Subject: WATER ENTRY INTO TRUNK LID LIGHT DURING HIGH PRESSURE CAR WASH	Bulletin No: 09-021/15
	Last Issued: 05/27/2015

2014-2015 Mazda6 vehicles with VINs lower than JM1 GJ ***** 170534 (produced before January 29, 2014)

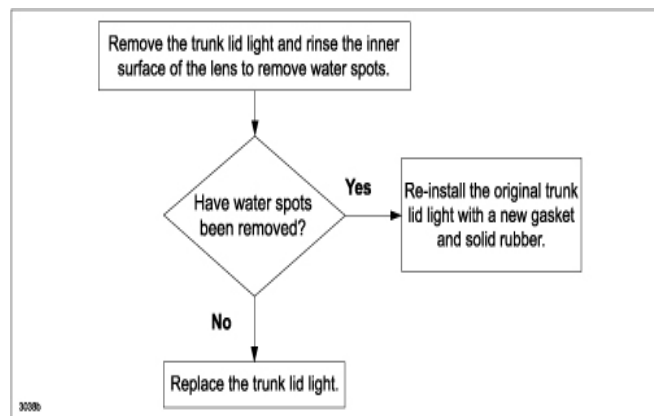
Some vehicles may exhibit a condition that water enters into the trunk lid light while washing the vehicle with high pressure. Water may enter through the trunk lid light gasket and the body panel.

NOTE: New trunk lid light includes gasket and the solid rubber.

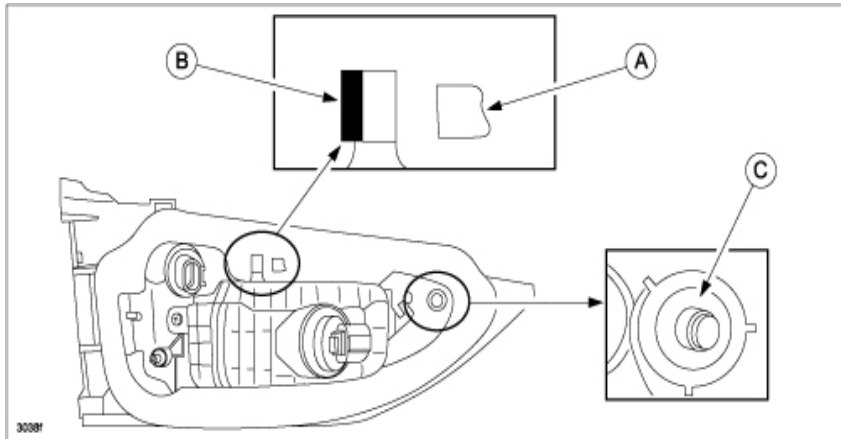
14. Attach the gasket (modified service part) to the trunk lid light.

- A double-sided adhesive tape is attached to both sides of the gasket. Peel off the release paper before attaching the gasket.
- Align the slit of the gasket and the position pin (B).
- Attach the gasket taking note of identification mark for Right (R) or Left (L) (A). Attach so that the gasket does not rest on the bolt flange (C).

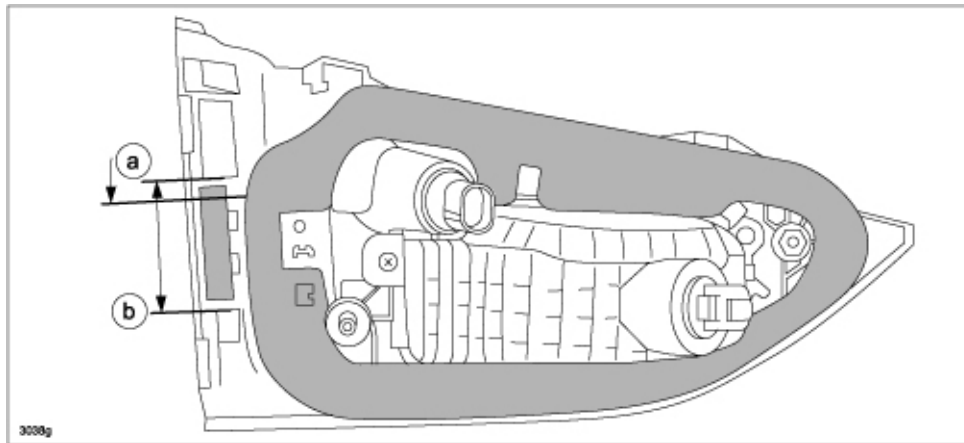
15. Peel off the release paper from the solid rubber and attach it to the trunk lid light between “a” and “b”.
